Our Ref: 2024/219480
File No: R/2022/20/A
Your Ref: SSD-49620481

Advice on Response to Submissions – Pyrmont East Over Station Development – SSD-49620481

Figure 1: extract from reference scheme section

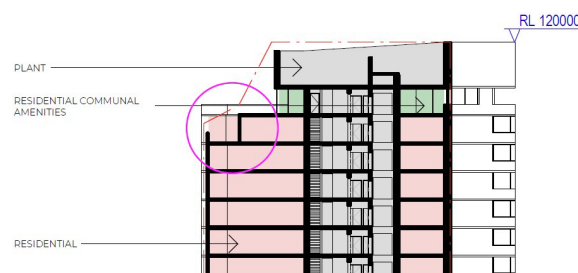
The Solar Access Report (Appendix M) does not identify or test the Solar Access Plane (SAP) to Elizabeth Healey Reserve to the south-west of the site. The *Pyrmont Peninsula Place Strategy – Urban Design Report* identifies the SAP requiring developments to ensure that there would be no additional overshadowing between 10am and 2pm in mid-winter.

c. ensure no additional overshadowing to Elizabeth Healy Reserve”

A 3D electronic model has been requested to enable testing to be undertaken to confirm the SAP is not broken by the proposed building envelope. A section provided through the building appears to exceed the SAP as shown in figure 1 below.
